6400 Brookville Road, Chevy Chase

PRELIMINARY CONSULTATION

MONTGOMERY COUNTY HISTORIC PRESERVATION COMMISSION
STAFF REPORT

PROPOSAL: Additions and alterations to house

1 Proposed Front Elevation
1/8" = 1'-0"

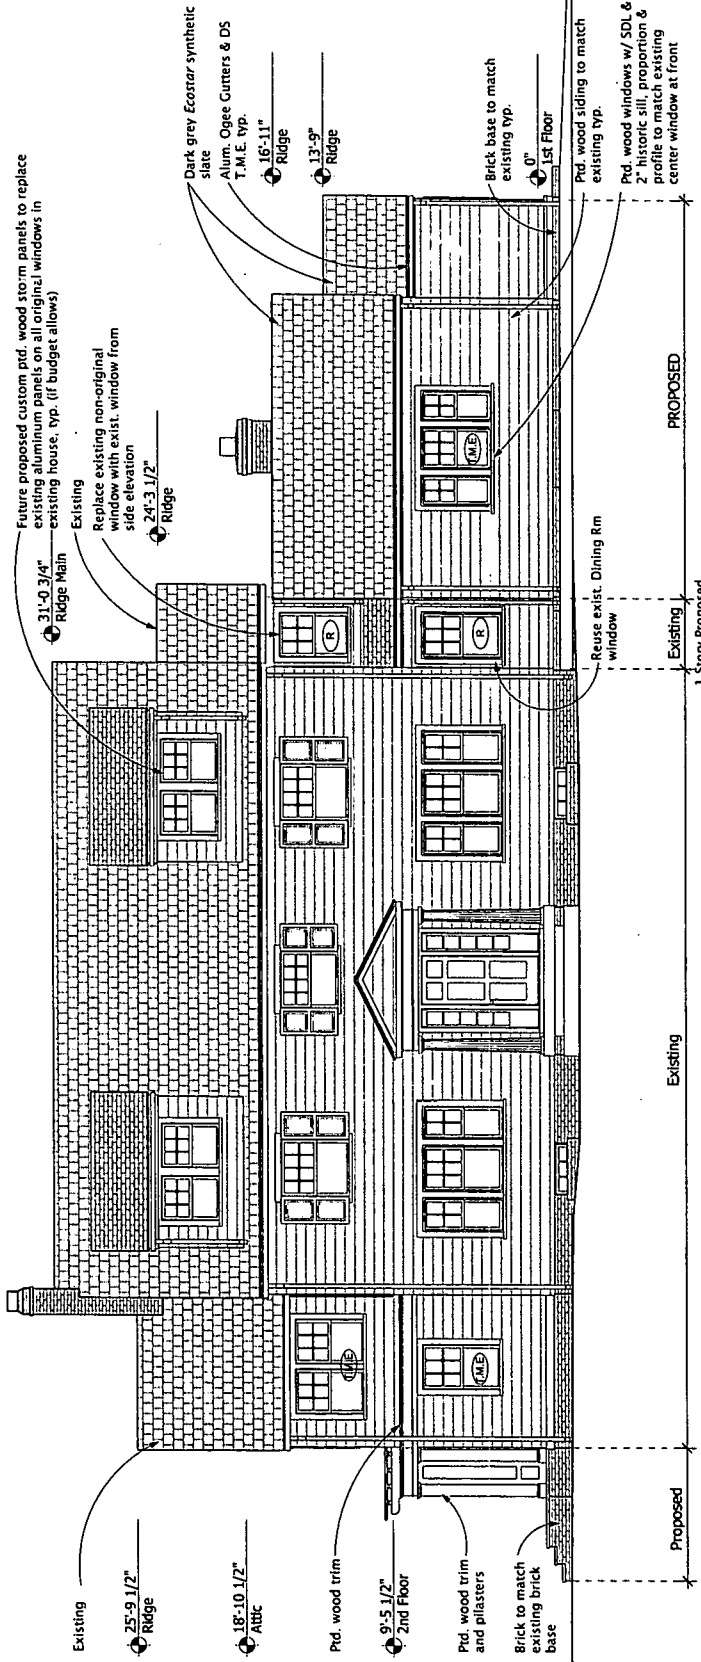
The HPC's main concern with the proposal was about the massing and detail of the proposed right elevation mudroom addition. The HPC found the height and detail for the mudroom as being too predominant and recommended that the scale and design be simplified. Recommendations included a flat or lower gable roof design and one that complemented the proposed left elevation flat roof entry design and details, which the HPC found compatible with the existing resource and historic district. Other design recommendations for the mudroom addition included a simple, toned down piece with horizontal siding. The majority of the HPC stated a simplified flat roof design complementary in design and massing to the proposed left elevation covered entry feature would be most appropriate.

This option was designed in response to some of the comments from the HPC at the 1st preliminary consultation. This approach includes a steeper 10/12 gable roof pitch to match the roof slope of the addition section and primary massing. A horizontal wooden siding is proposed in lieu of the panelized and pilaster design proposed in option A.

5'-0" x 13'-0"
 Bump-out

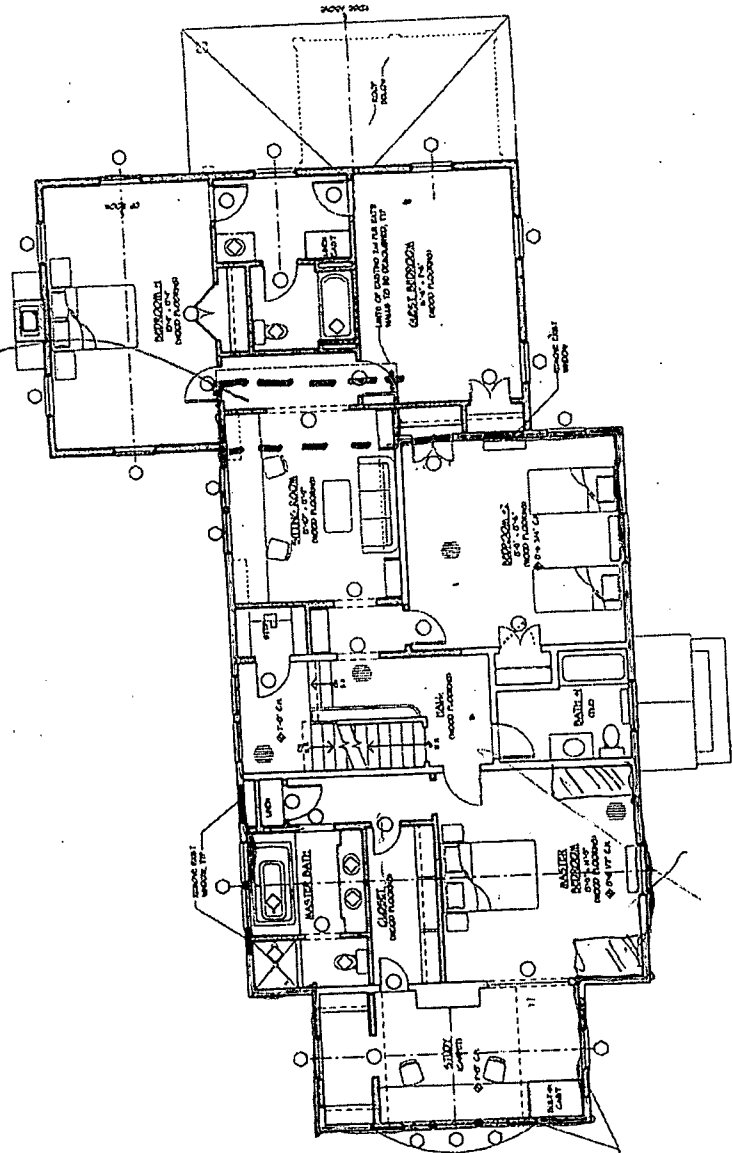
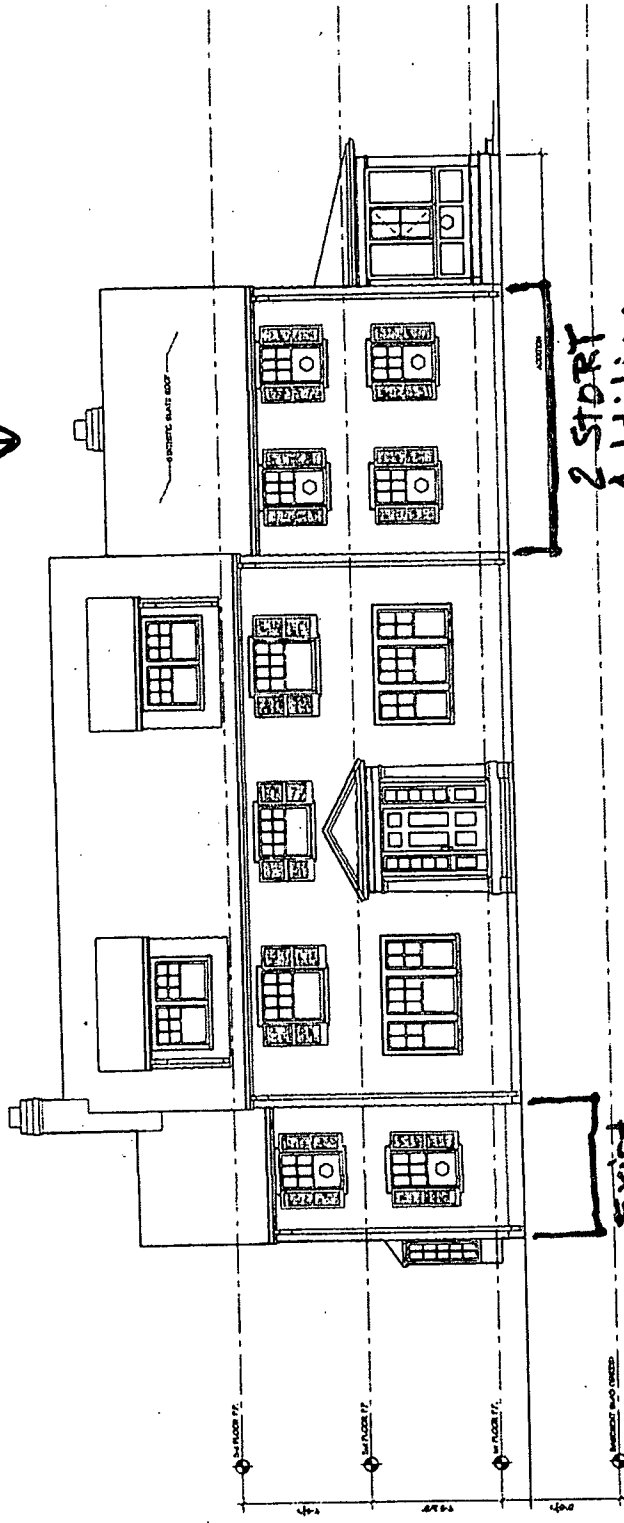
Our question is: can we integrate the existing 2 story bump-out (measuring 5'-0"x13'-0") into the new addition or does it need to remain expressed on the exterior – which would then require us to design a hyphen or transitional space between the main house and the new addition. Architecturally we think it might benefit the overall appearance of the house to not do that but connect the addition directly to the main house (similar to what is shown on the front elevation of the attached drawings).
